## ADDENDUM NO. 1

Issue Date: March 27, 2025

Project Name: Van Buren Public Schools  
RAHS Belleville High School  
West Columbia Avenue  
Belleville, Michigan

IDS Project No.: 24167-1000

M4.1

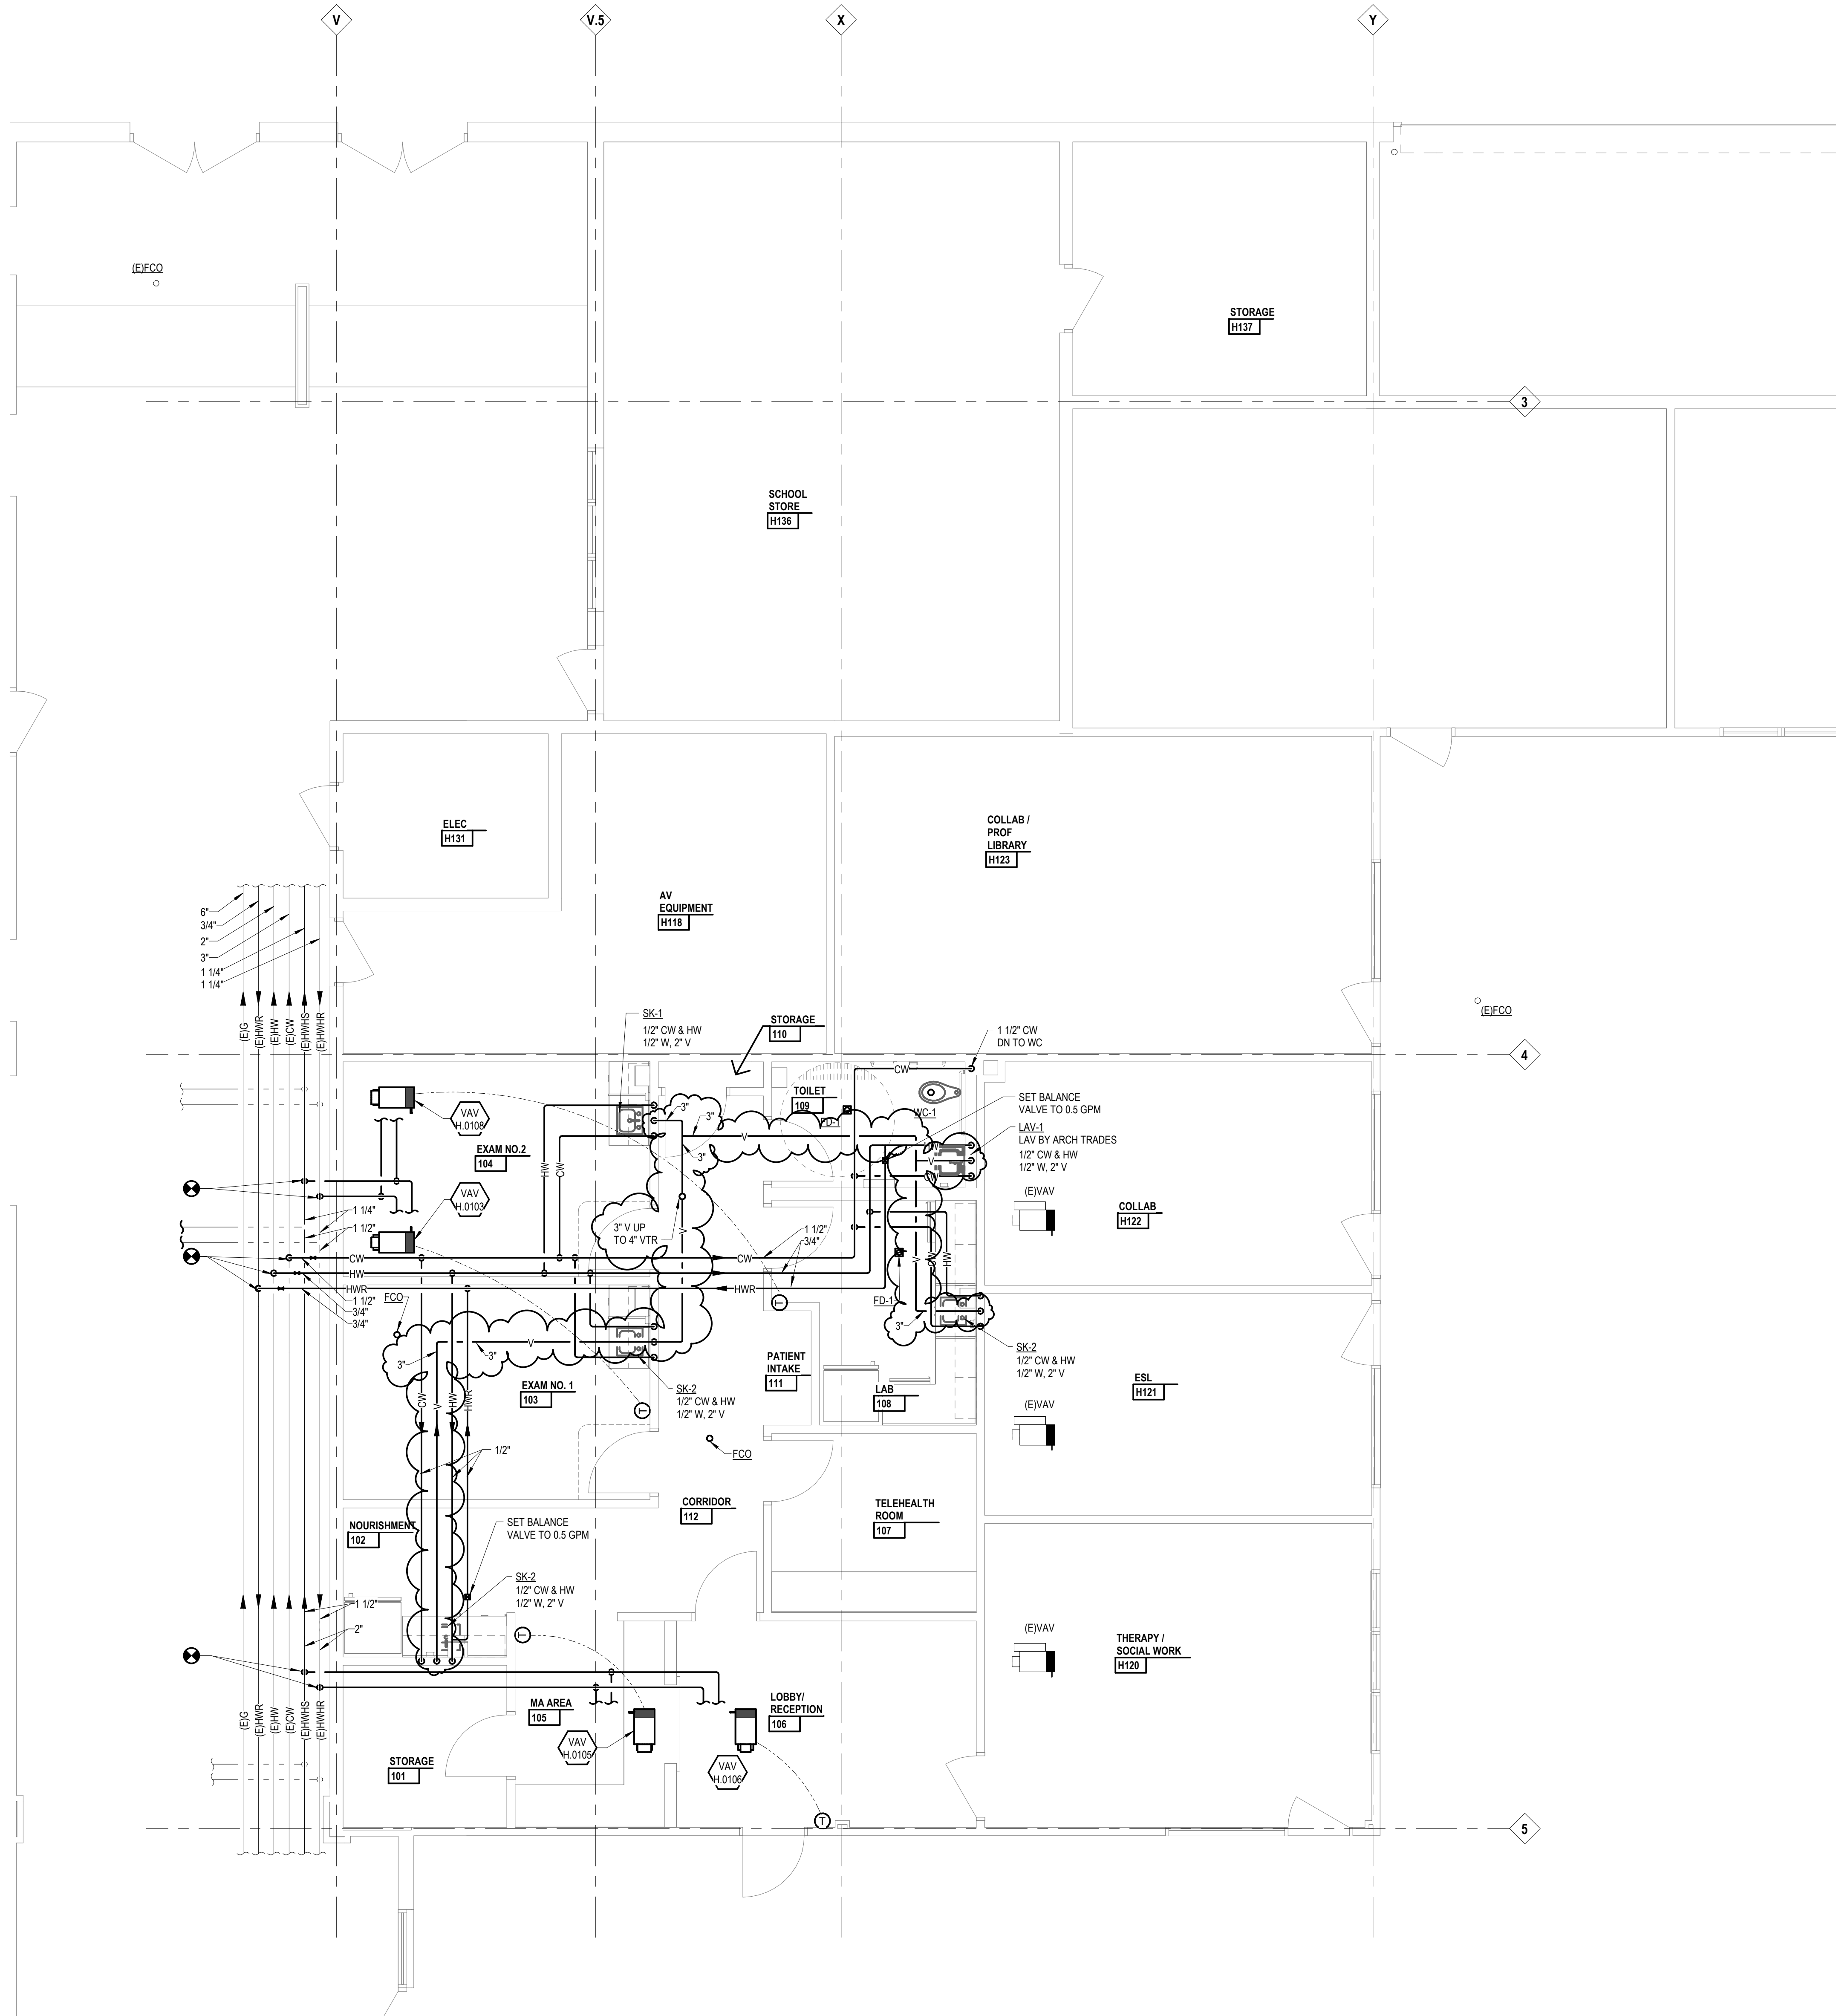
RFI NO.		DESIGN TEAM RESPONSE
001	<p>According to the plumbing drawings there will be 3 new tie ins at the domestic mains in the hallway.</p> <p>Currently in the room there are 3 domestic lines running within 10' of where the drawings show the lines to be installed. Can the current placement and even existing lines be used, if they coordinate with the drawings sizing?</p>	<p>Based on new domestic water load, the current pipes are undersized and were removed back to the plumbing mains to be replaced with the proper size. Follow new work drawings for pipe sizes.</p>
002	<p>According to the plumbing drawing the sanitary vent is to tie into an existing vent in the ceiling.</p> <p>Currently in the room there is no sanitary vent located in the hallway or inside the room.</p> <p>The current venting situation is an automatic air vent in the ceiling, which will not pass code, because the ceiling is used as a return air plenum. There will need to be a new vent penetration through the roof.</p>	<p>Drawings within Addendum No.01 will be revised with the updated vent routing and vent through roof location.</p>
